P2D2Pi Pi Header pinout variant, of P2D2

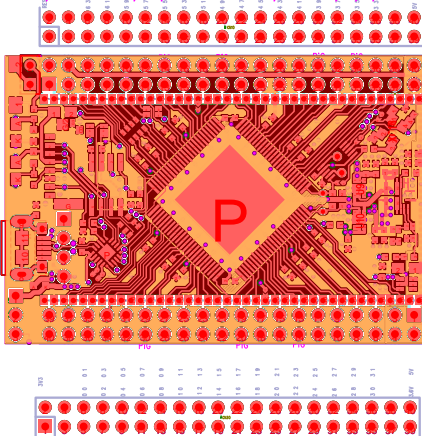
AP7332 -> 2 x NCP187, Better PSRR, Lower Noise, better thermally Higher Io
 Added more copper, and many more Thermal Vias
 Original Vias Count : 128, Revised : Via Count : 202
 Simplified POUR and set up for 4 layer PCB, MAX GND planes

JG: Pi Hdr, Matches 5V,3v3,GPIOs & 3 GNDs, Pins 30,20,14,9 are P2.io

JG: Added RN2, U5,UC1 - PJB revs
 JG: Fixed XG1 MSOP10 to 0.5mm

JG: Added C14, J2, J6, C11, X01a (3225 X0) X01B (5032) new parts

JG: Added J4,J5 for EFM8UB3 C2D debug

JG: Changed USB to 10118194. moved to board edge

NCP187 LDO similar (NPC) : DFN2020, EN>IN, Higher noise TLV75533PDRVR 0.5A & TLV75733PDRVR 1A

NCP187 PAD 1.12x1.72 TLV75533PDRVR PAD 1x1.6 CL=0.65mm

JG:Jumper on VIO on Pi Connector (avoids Pi.3v3 contention P2.3v3 ?)

JG: VIO, or VA, VB best to connect to Pi.3v3?

JG: Pi5V to Vcc, or maybe to VIN or VBUS ?

JG: PADS Clearance as imported 23, Min 3.9mils

JG:PADS connectivity as imported 20

JG:P2D2r2p fill areas rationalised, cleanups, Zero DRC Errors
